Model: LCIT PB3170	Date: 26-Jun-13	No.: RD695001c
--------------------	-----------------	----------------

Subject: Firmware Release Note: LCIT PB3170		Prepared by: Y. Ino	
From: 1st Tech Service Sect., MFP/Printer Tech Service Dept.			
Classification:	<input type="checkbox"/> Troubleshooting <input type="checkbox"/> Mechanical <input type="checkbox"/> Paper path <input type="checkbox"/> Product Safety	<input type="checkbox"/> Part information <input type="checkbox"/> Electrical <input type="checkbox"/> Transmit/receive <input checked="" type="checkbox"/> Other (Firmware)	<input type="checkbox"/> Action required <input type="checkbox"/> Service manual revision <input type="checkbox"/> Retrofit information <input checked="" type="checkbox"/> Tier 2

Model: LCIT PB3230		Date: 12-Feb-15	No.: RD695004
Subject: Parts Change information		Prepared by: Yamada Yasutaka	
From: 1 st Tech Service Sect, MFP/P Tech Service Dept			
Classification:	<input type="checkbox"/> Troubleshooting <input type="checkbox"/> Mechanical <input type="checkbox"/> Paper path <input type="checkbox"/> Product Safety	<input checked="" type="checkbox"/> Part information <input type="checkbox"/> Electrical <input type

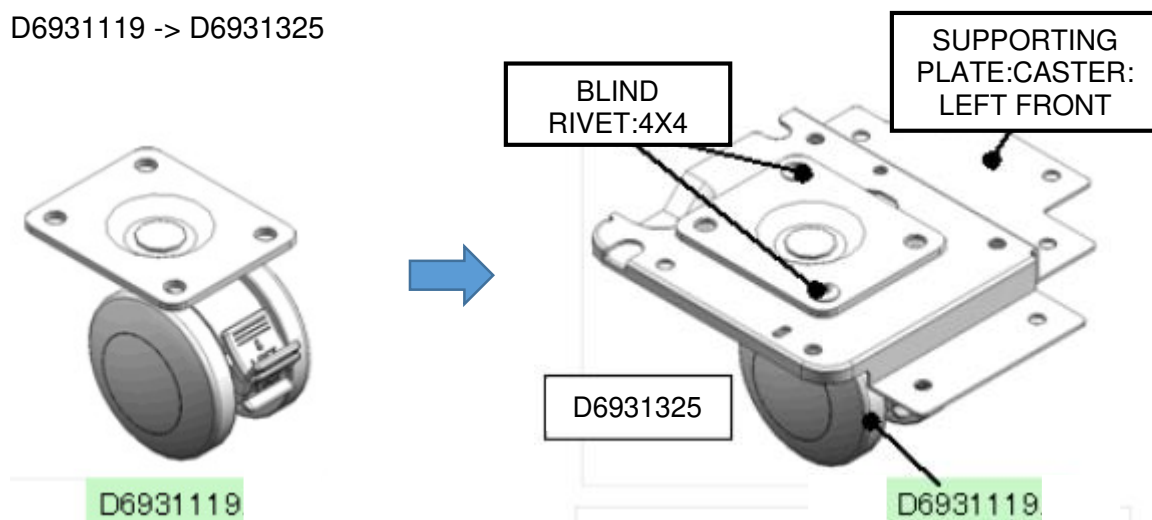
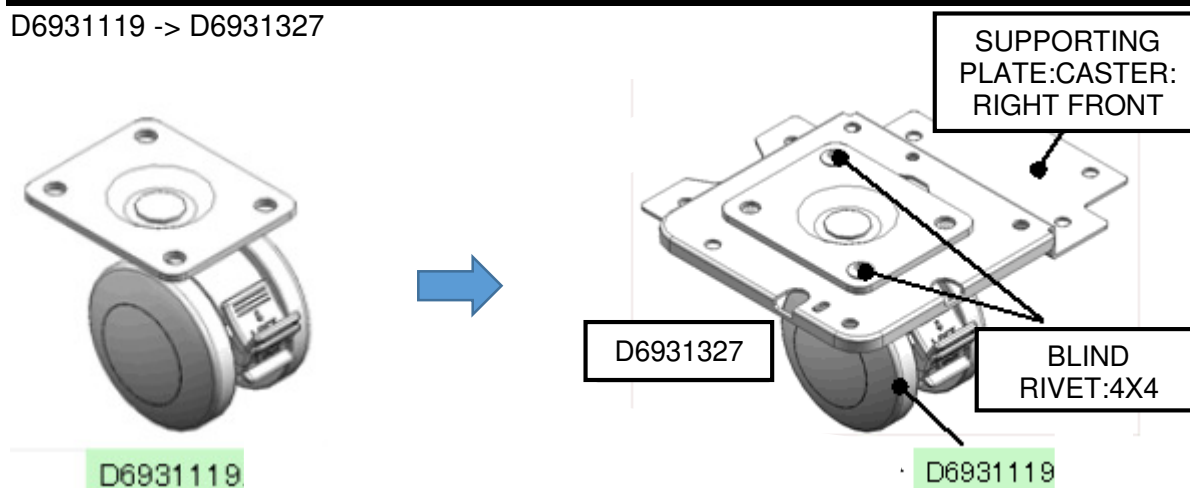
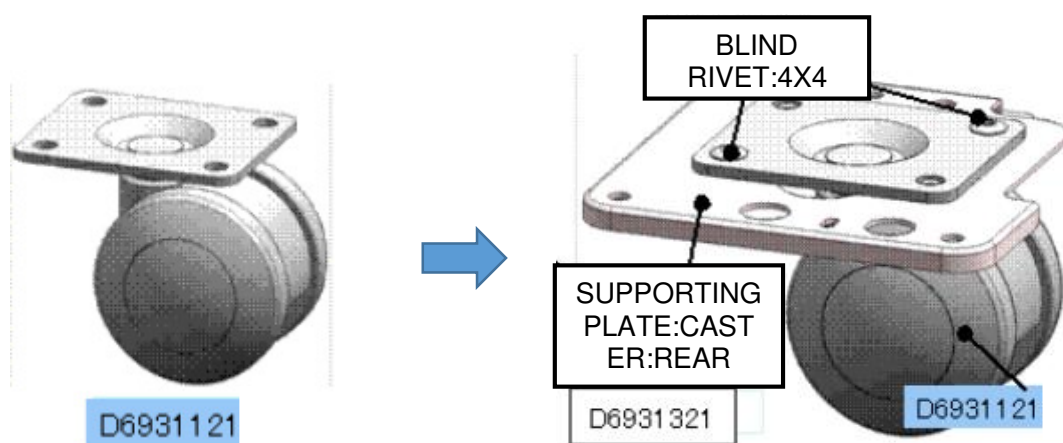
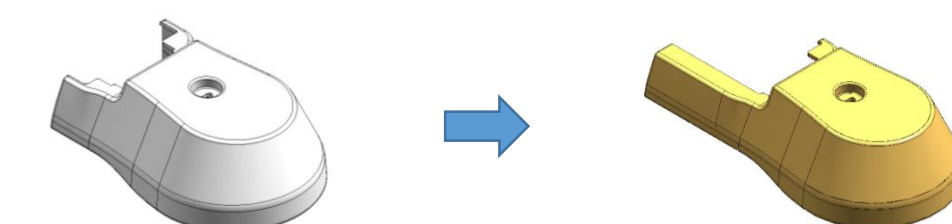
1. The caster and plate were registered together as an assembly.
2. The shape of the arm cover was changed.

1. To improve the part's strength against shock vibration.
2. To make the part easier to replace in the field.

D6931119 -> D6931325

D6931119 -> D6931327

D6931121 -> D6931321

D6931221 -> D6931222

Old D1492721	New D6942721
Shape		 <ol style="list-style-type: none"> Deleted stopper Changed angle regulation Strengthened part
Angle

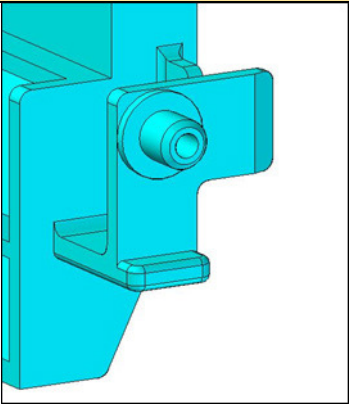
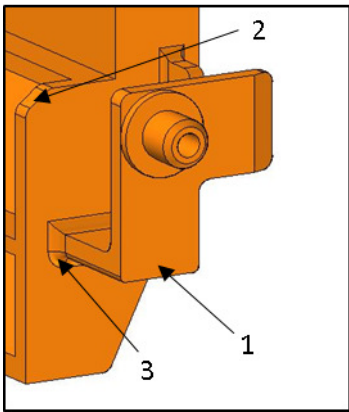
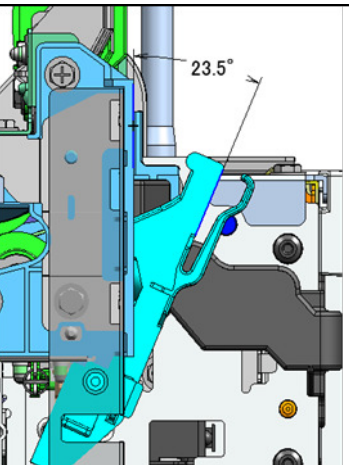
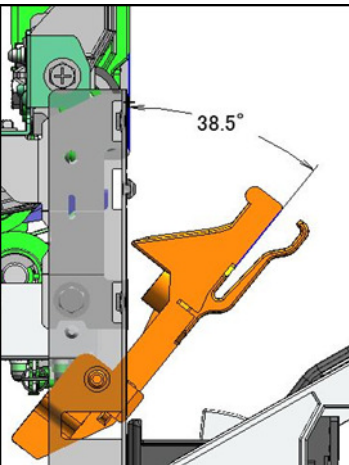
Change: The shape of the guide plate was changed.

Reason: To further strengthen and prevent breaking of the guide plate.

1. Release the hook and remove the guide plate.

2. Attach the guide plate by sliding it toward the right hole.

3. Hook the guide plate.

Old P/N	New P/N	Description	Q'ty	Int	Int
D6932526	D6932581	GUIDE PLATE:SWIVEL:No.3	1-0	X/O	X/O
	D6931157	CUSHION:GUIDE:SWIVEL:UP PER	0-1	-	-
	-	GUIDE PLATE:SWIVEL:NO.3	0-1	-	-
D6932725	D6932726	GUIDE PLATE:AUXILIARY:PAPER FEED UNIT	1-1	-	O/O

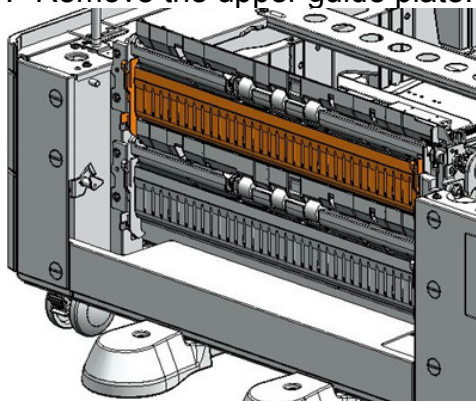
Change: Added cushions and changed the shape of the guide plate.

Reason: To further strengthen and prevent breaking of the guide plate.

Important: Be sure to attach the above CUSHION when installing the paper guide plates.

Old P/N	New P/N	Description	Q'ty	Int
D6932526	D6932582	GUIDE PLATE:SWIVEL:No.3	1-0	X/O
	D6931257	CUSHION:GUIDE:SWIVEL:LOWER	0-1	-
	-	GUIDE PLATE:SWIVEL:NO.3	0-1	-

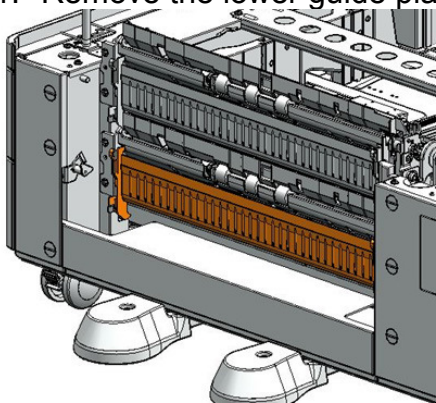
Change: Added cushions and changed the shape of the guide plate.

Reason: To further strengthen and prevent breaking of the guide plate.

Important: Be sure to attach the above CUSHION when installing the paper guide plates.

Old P/N	New P/N	Description	Q'ty	Int
D6932526	D6952581	GUIDE PLATE:SWIVEL:No.3	1-0	X/O
	-	STOPPER:GUIDE PLATE:SWIVEL:ASS'Y	0-1	-
	-	GUIDE PLATE:SWIVEL:ADHESION	0-1	-

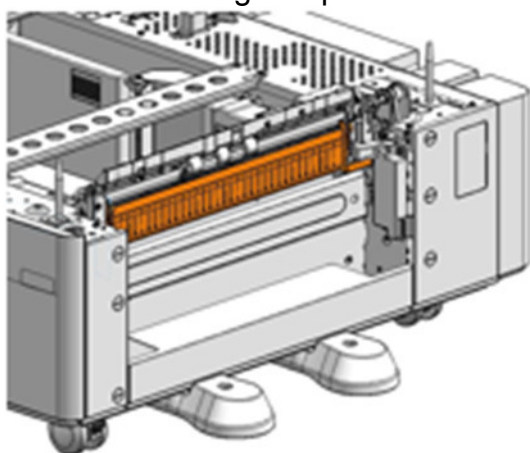
Change: Added cushions and changed the shape of the guide plate.

Reason: To further strengthen and prevent breaking of the guide plate.

Important: Be sure to attach the above STOPPER, when installing the paper guide plates.
